Application for Works Approval

Works Approval Number W6969/2024/1

Applicant Aragon Resources Pty Ltd

Premises Fortnum Gold Operations
L52/172, M52/5, M52/6, M52/95, M52/96, M52/98, M52/99,
M52/125, M52/132 and M52/133
PEAK HILL WA 6642

Figure 2: NPTSF proposed (N1, N2, N3 and N4) and existing (MB01) monitoring bore locations

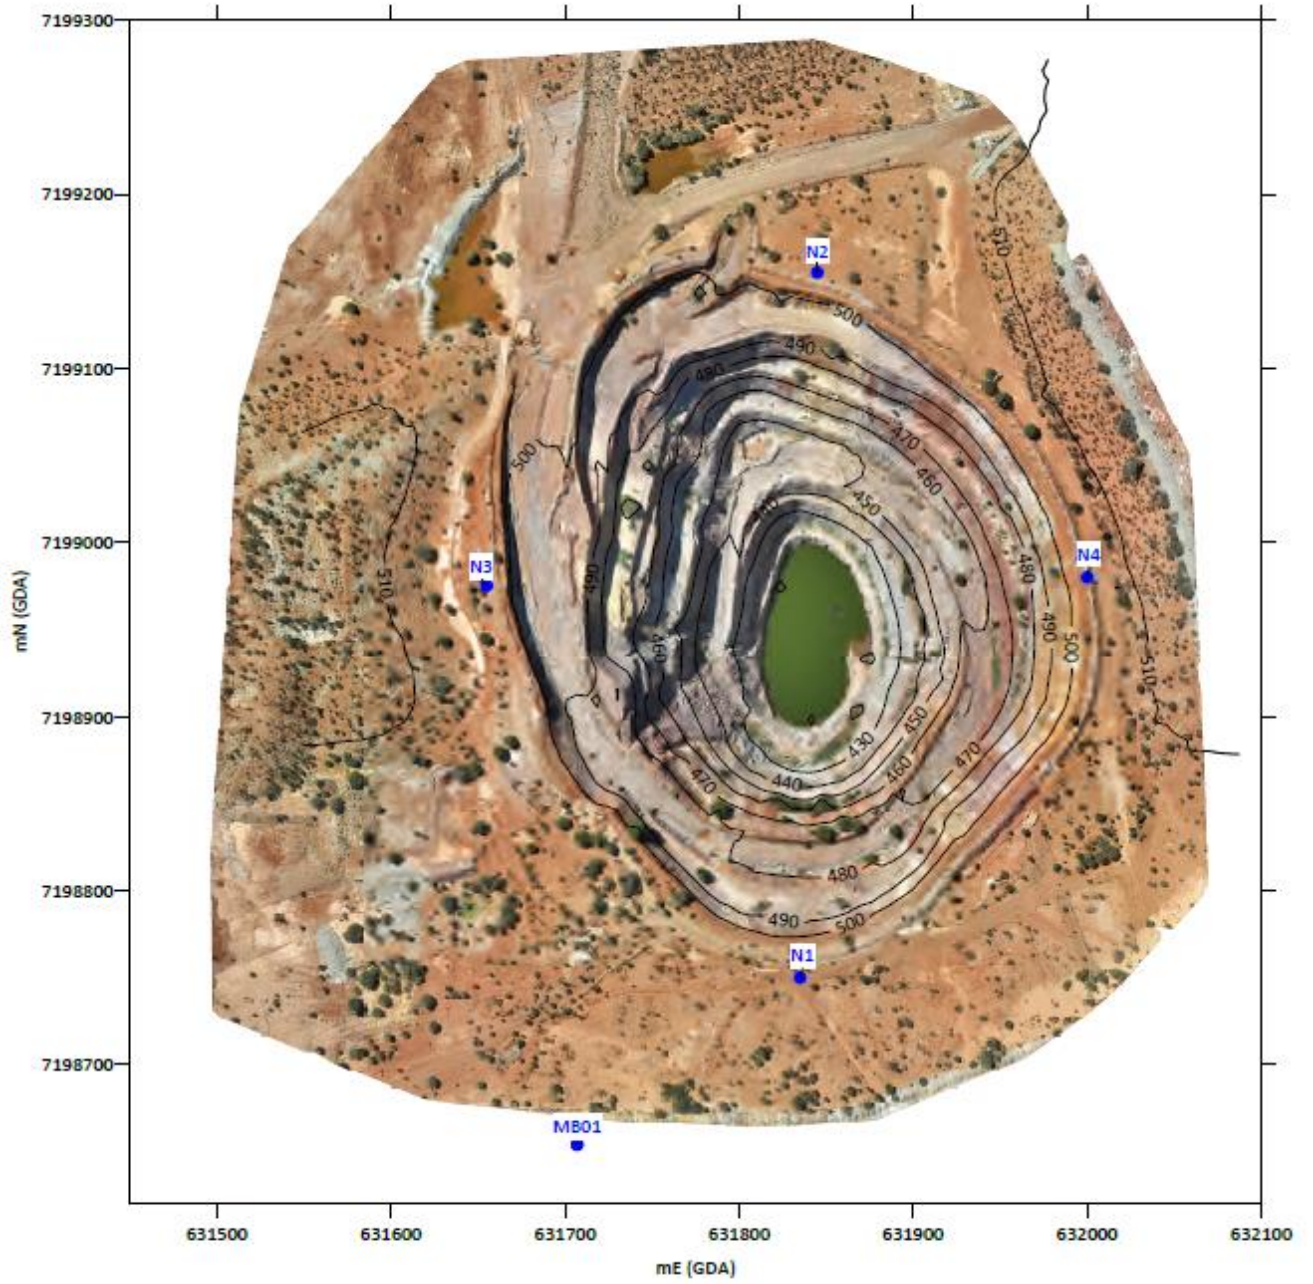
To monitor groundwater level and quality around the NPTSF, the applicant has proposed to install four additional monitoring bores (N1, N2, N3 and N4). An existing bore MB01 will also be incorporated.

The department has conditioned the construction of the proposed four monitoring bores through condition 2.

Under condition 7 the applicant must within 30 days of the monitoring bores being constructed and **prior to environmental commissioning of the NPTSF** conduct baseline sampling (at least one event) from the five bores (N1, N2, N3, N4 and MB01).
